PLAN COMMISSION AGENDA Wednesday, May 28, 2025 at 7:00 PM

Conditional Use and Design Review Application: Surplus Suds, 301 W Main Street, Chad Ferguson of Keller Inc

To: Village of Mount Horeb Plan Commission
From: Village Planner Ben Rohr, AICP
Date: May 28, 2025
Re: Village Planner's Conditional Use, Site Plan, and Design Review Comments for a Proposed Mixed Use Building for Matthew Lust at 301 W. Main Street.

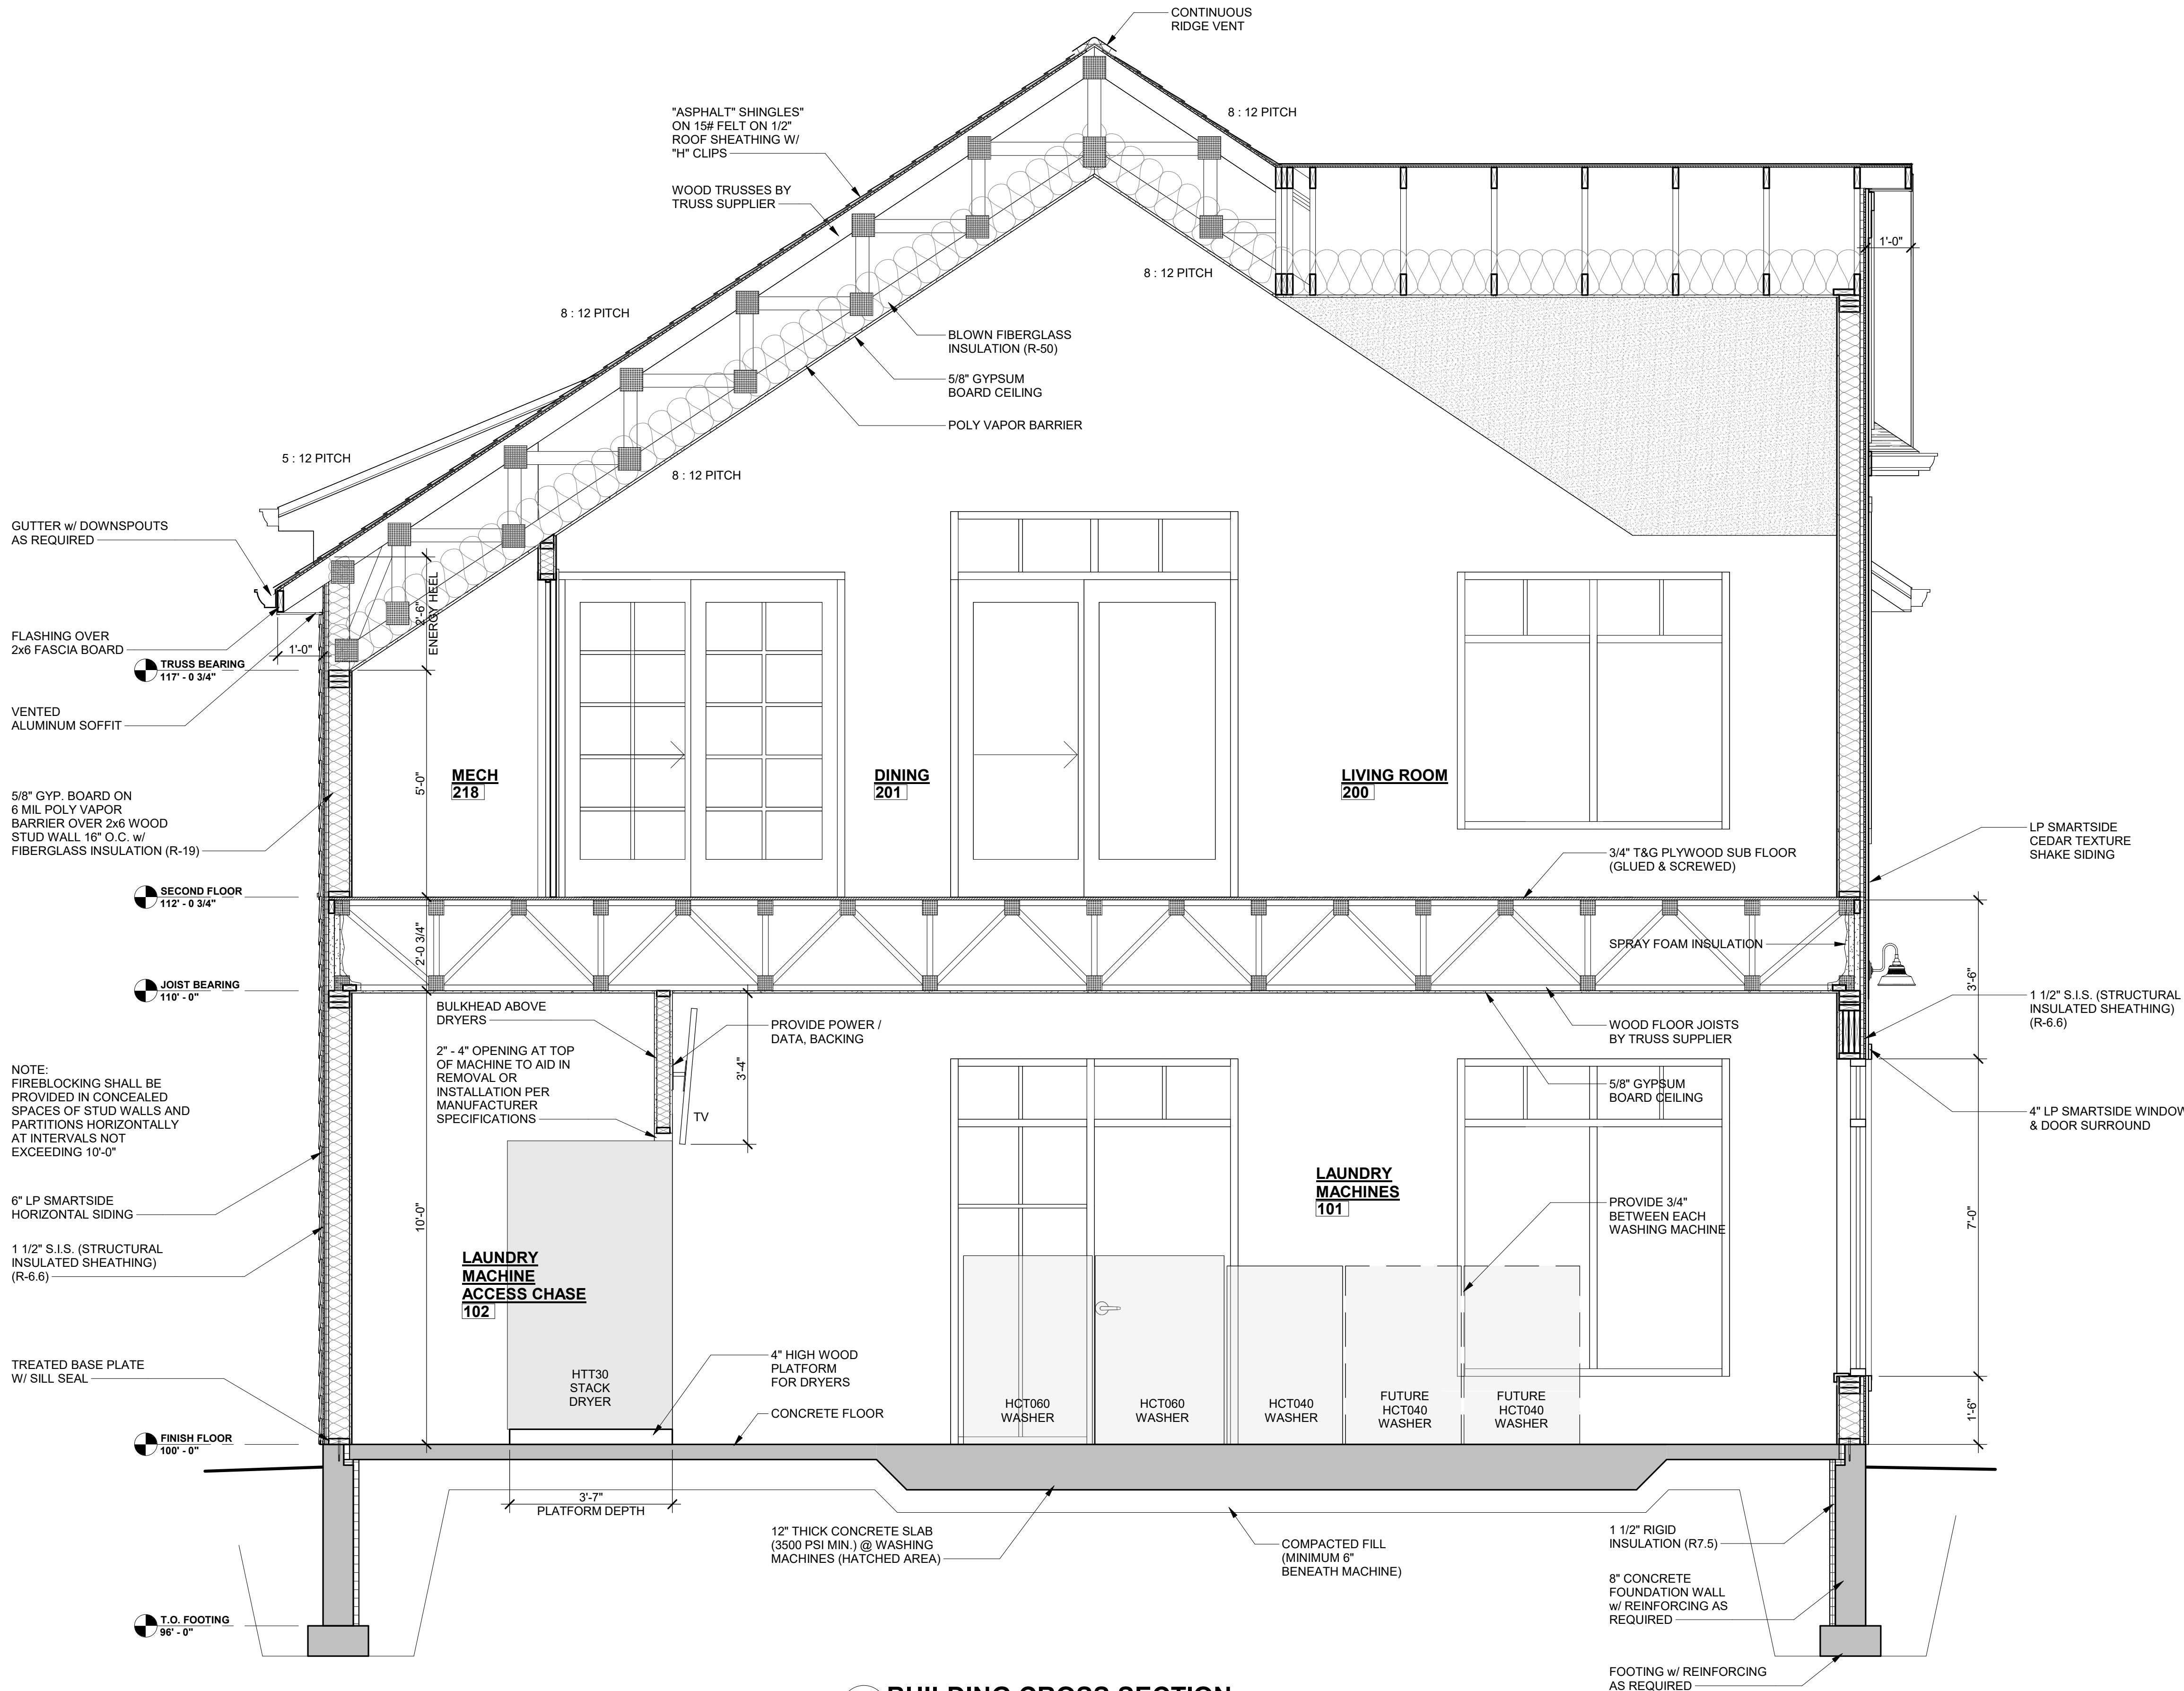
- This requirement is met on the north, east, and south sides of the structure through the use of varying building materials, window/door openings, and varying pitches to the roof. This requirement is not met on the unarticulated western façade. However, I recommend the Plan Commission waive this requirement because it is reflective of the residential architectural style of other buildings to the west and will (mostly) not be visible from Main Street.

3. Site Plan and Design Review packet, including waivers for:
 - a. 7.a. Allow the unarticulated western façade, as depicted.
 - b. 7.d. Allow a non-traditional storefront design to be used on the ground and upper floor of an intersecting street within the Central Business District, as depicted.
